Charlotte Department of Transportation

Memorandum

Subject: Rezoning Petition 15-005: Approximately 108.86 acres located on the south side of Choate Circle and at the southern intersection of Moss Road and Choate Circle.

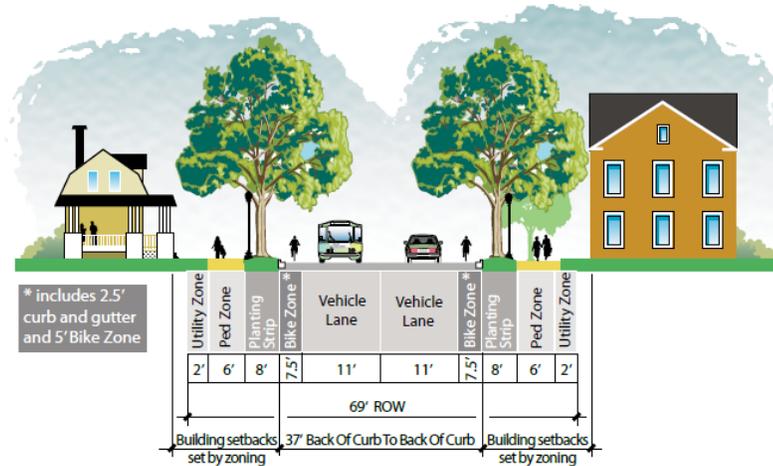
1. Regarding notes 1-3 in the Transportation Commitments section of the rezoning petition, the references to Choate Circle being constructed to collector street standards are based on outdated City standards. We request that if frontage improvements are required along Choate Circle they be constructed as per recommendations in the Steele Creek Area Plan. The Area Plan calls for a two-lane avenue section. See excerpt below.

Avenue ~ Two Lane Undivided

Width: 37' from back of curb to back of curb. ROW is 69'.

Cross Section: One travel lane in each direction with bike zone, planting strip, sidewalk and utility zone. If a turn lane is added, an additional 11' is required. Building setbacks will vary by zoning districts.
